STATE OF WASHINGTON  
DEPARTMENT OF ECOLOGY

August 26, 2011

**RE: Pend Oreille Temperature TMDL Dispute**

Figure. Relationship between measured (monitoring) and model-predicted (profile) temperatures for model segment 334 (river mile 38).

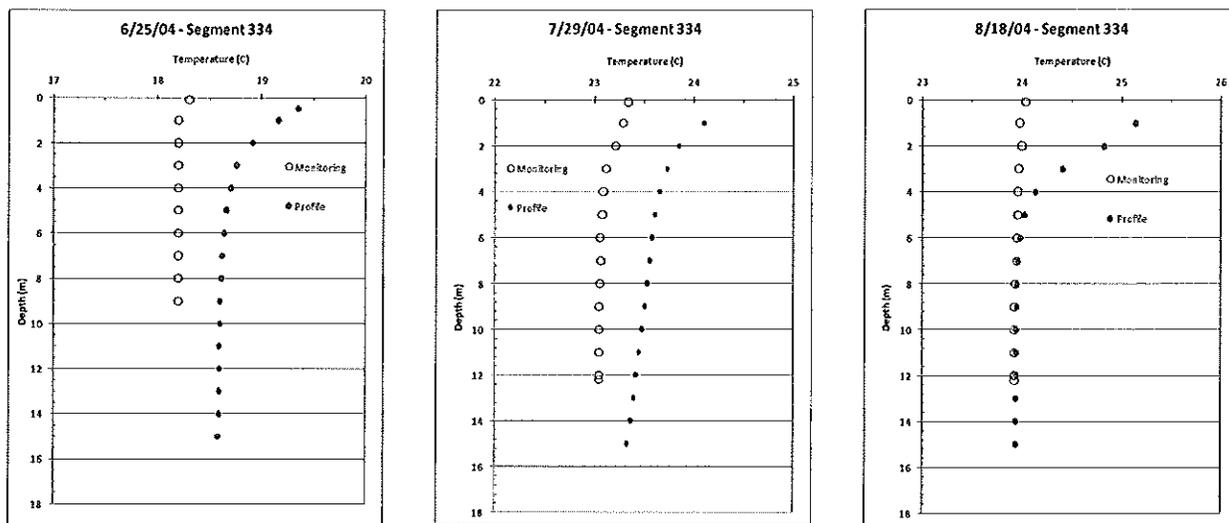
**Dispute Claim PUD -1:** Maximum surface temperatures are not representative of conditions in the river and should not be used to assess compliance.

**Decision-Do not change TMDL.** *Department of Ecology's (Ecology) Water Quality staff reviewed the model and met with Environmental Assessment Program staff that were responsible for the modeling. Summer-period water column temperatures measured late-July and mid-August (2004) indicate distinct differences in comparison to those predicted by the TMDL model (refer to figure below). Measured*

water column temperatures observed during monitoring events indicate only slight temperature variation whereas the model output displayed a consistent pattern of increased heating with decreasing depth (comparisons retained same location and times). This surface “flare” pattern was most pronounced for depths less than approximately 4-meters. Though segment 334 is displayed in the figure, this pattern was common among the 14 monitoring locations examined within the section of the river between the Washington/Idaho state-line and the Box Canyon facility. Ecology agrees that this relationship could be a concern because the TMDL analysis used daily maximum temperatures which occur within the very upper portion of the water column. In addition, the model-predicted temperatures were consistently greater than those observed during monitoring at the majority of the monitored locations again with the greatest differences occurring at shallower depths suggesting model bias.

Figure. Relationship between measured (TidBit) and model-predicted daily maximum temperatures for segment 334 (Tiger reach, river mile 38.3).

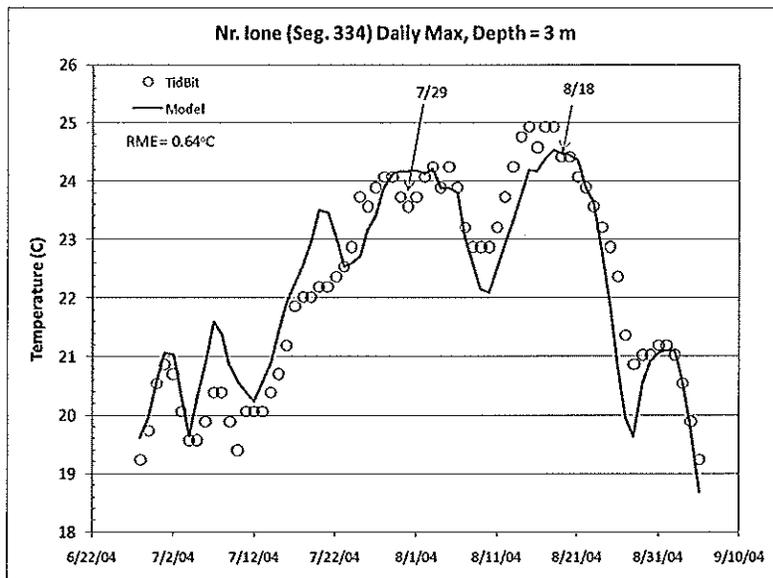
Importantly, there is not the systematic model bias present suggested by the comparison of “snapshot” measured and modeled vertical temperature profiles. In fact, referring to the figure below, for segment 334 on July 29, the model-predicted temperatures are slightly higher than measured by the TidBit while on August 18 they’re close in magnitude, similar to the relationship presented in the figure above. This indicates the importance of taking a longer-term perspective when making these types of comparisons to account for overall variability. The TMDL was not based on one day rather it considered when temperatures were above 20°C a situation which, in 2004, occurred over an approximately 60-day period (below figure).

While the examination of temperatures at 3-meters indicates the model provides a reasonably good fit between measured and predicted temperatures what about for shallower depths? Unfortunately, there were no TidBit data-loggers set for depths shallower than 3-meters in reaches the TMDL found to be the most impacted by the Box Canyon facility (Tiger and Forebay). So there is no means to confirm the increased heating the model predicts for shallower depths.

Figure. Temperature differentials based on the TMDL in comparison to daily maximum temperatures at 3-meters. (Differentials greater than 0.3°C (vertical red line) indicate a temperature impairment.)

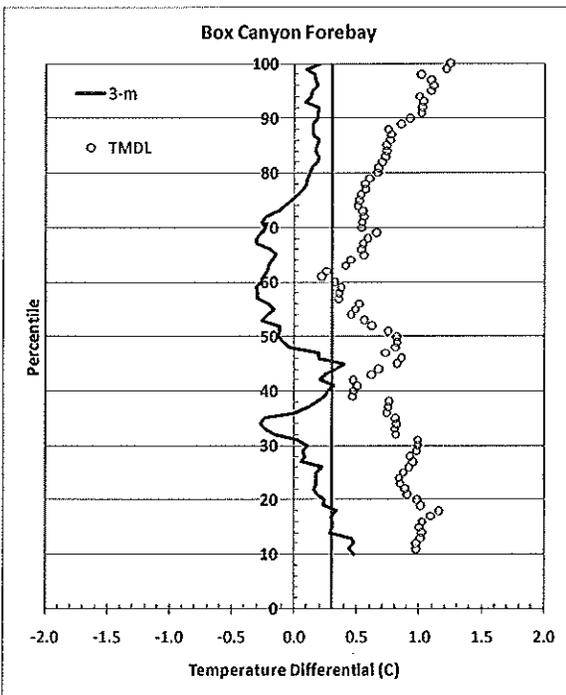
A temperature impairment is still found for the Box Canyon forebay reach when the daily maximum temperatures at 3-meters are used, as opposed to the water column daily maximum (TMDL approach), though predictably the level of impairment is considerably lower (refer to figure below).

- The temperature model applied in the Pend Oreille River TMDL, based on a longer-term relationship between predicted and measured daily maximum temperatures (seven locations) within the Box Canyon affected section of the river, appears well calibrated.

- For the majority of the monitoring locations, this assessment of calibration occurs at a depth of 3-meters. This depth is approximately the inflection point that model-predicted temperatures were found to increase at a higher rate for shallower depths in comparison to those measured during routine water column monitoring.

- Temperature data-loggers were not set for depths shallower than 3-meters in the sections of the river found to be most affected by the Box Canyon facility (Box Canyon forebay and Tiger reaches). For this reason, there is no means to either directly confirm or deny that the model found to be well calibrated at 3-meters is also well-calibrated for shallower depths. Violations of the criteria exist 3 meters below and the model is valid for the purpose of moving forward with the TMDL. However further sampling and analysis will be helpful as part of the 10 year evaluation.
